Access Compliance Report

Public Rights-of-Way

(Pedestrian Signals)

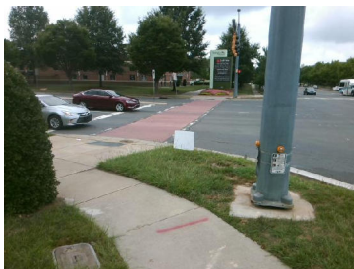
PROW/ADA: TMUTCD 4e.08, R404.1, R404.7.1, R404.7.2

Possible Solutions: Replace Signal Push Button With APS Button on New Post. Remove & Relocate Sign.
